Report to Sydney Central City Planning Panel

Panel Reference	2018SWC051
DA No.	DA/712/2016/D
LGA	City of Parramatta
Proposed Development	Section 4.55 (1A) Modification application to an approved 2 x 5 storey Residential Flat Building comprising of 130 units with 2 levels of basement car parking.
	The modifications include retrospective approval for the use of the 2 x signage structures for the purposes of 'building identification' (located on Cliff Road and Carlingford Road) and 4 signs and changes to conditions of consent.
Street address	1 Cliff Road, Epping
Applicant / Owner	Gordon HLHS Epping Pty Ltd / Gordon HLHS Epping Pty Ltd
Date of DA	1 March 2018
Lodgement	
No. of Submissions	15 submissions
Recommendation	Refusal
Regional Development Criteria (Schedule 7 of the SEPP) State and Regional Development 2011	The parent application was determined by the former Sydney West Joint Regional Panel.
List of All Relevant s4.15(1)(a) Matters	<ul style="list-style-type: none"> • Environmental Planning and Assessment Act and Regulations • State Environmental Planning Policy No. 64 – Signage and Advertising • Hornsby Local Environmental Plan 2013 • Hornsby Development Control Plan 2013

Re

Figure 7: Location of Sign 1 facing Cliff Road (elevation view from Cliff Road).

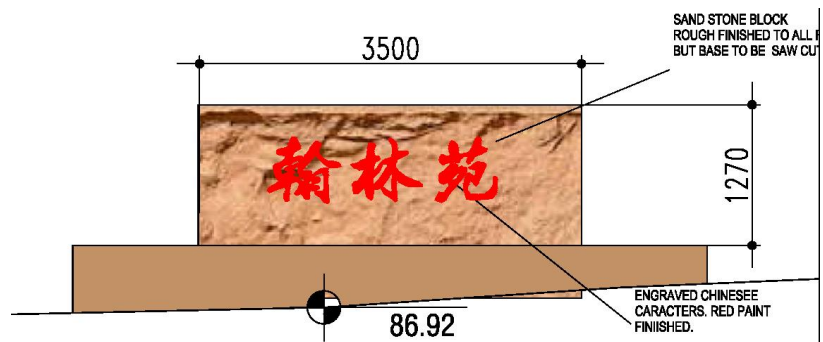
<p>It is noted that Sign 1 which contains the Chinese characters was not supported under the modification application. Accordingly, Condition 3A was imposed to delete the sign from the plans and to reinstate the lapped and capped fencing along Cliff Road to screen the sandstone structure from the streetscape.</p>
--	--

Figure 12: Proposed signs on Cliff Road frontage.

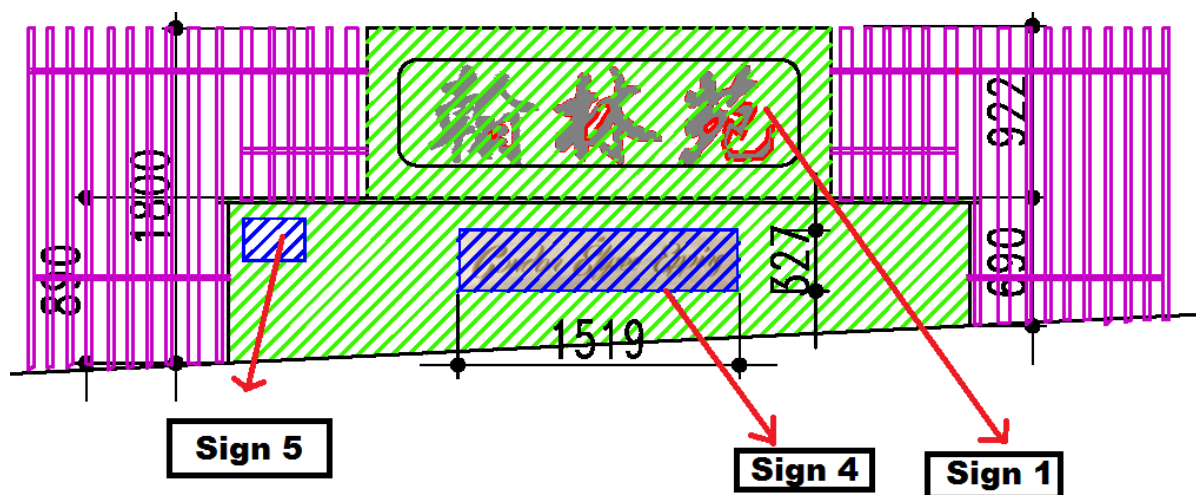
Whilst all the signs (with the exception of Sign 5) refer to 'names' as per the above definition, the application has failed to demonstrate how these signs identify or relate to the building on the site.

Sign 1 in isolation cannot be understood by the public without an understanding of the Chinese language. As such, the building on the site cannot be identified by all users and is therefore not a "building identification sign". This is further highlighted by the introduction of Sign 5 which is not a translation of the Chinese sign, but rather a philosophical statement of

the sentiment of Sign 1. For this reason, both Sign 1 and Sign 5 are not permissible on the site as they are not 'building identification signs'.

Figure 13: Proposed sign (Sign 3) on Carlingford Road frontage.

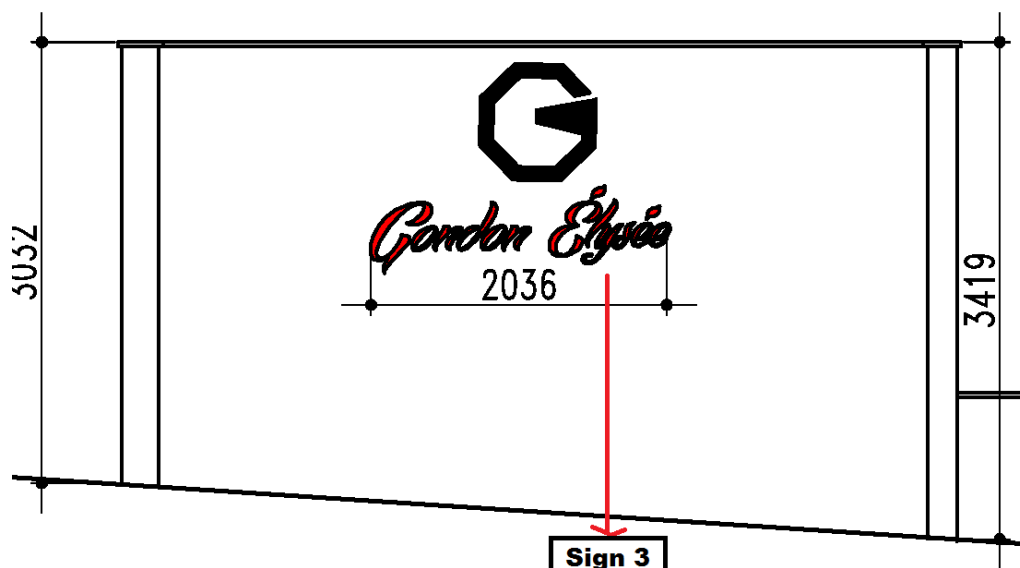
It is noted that the as-built Sign 3 is currently black in colour. However, the submitted plans appear to change the colour of 'Gordon Elysee' to red.

- The signage structure on Carlingford Road is constructed from sandstone and solid in nature. The structure has a maximum height of 3.419 metres with a width of 5.7 metres. This structure was constructed without Council consent.

Figure 15: Proposed Sign 4 on Cliff Road frontage.

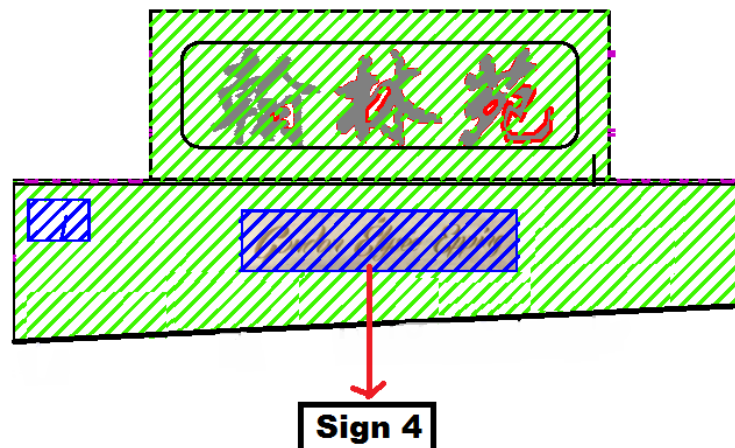
The application has also not demonstrated how the remaining signs (Sign 4 and 5) relate to the approved residential flat building notwithstanding that they contain similar content. These signs are not located in a location such as an entrance that readily identifies the specific residential flat buildings. There is ambiguity to their purpose and meaning when viewed by the wider public.

Figure 17: As built Sign 3 on Carlingford Road.

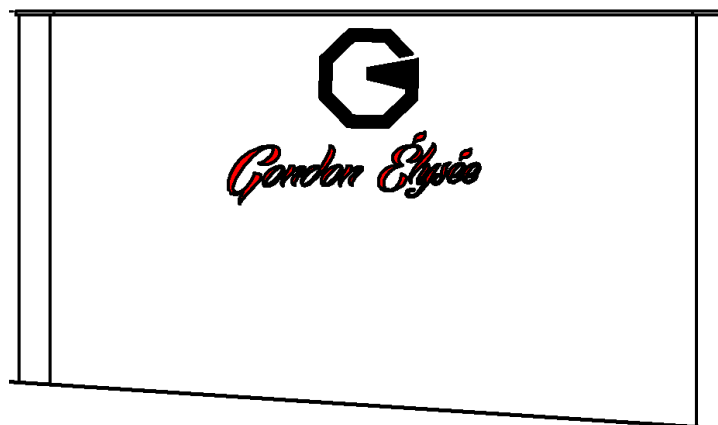
It is noted that the as-built Sign 3 is currently black in colour. However, the submitted plans appear to change the colour of 'Gordon Elysee' to red.

The word 'Gordon' and 'G' are a registered trademarks and the name of the applicant of the subject application.

"Elysee" is a reference to the French palace which is the official residence of the president of France or the French Government.
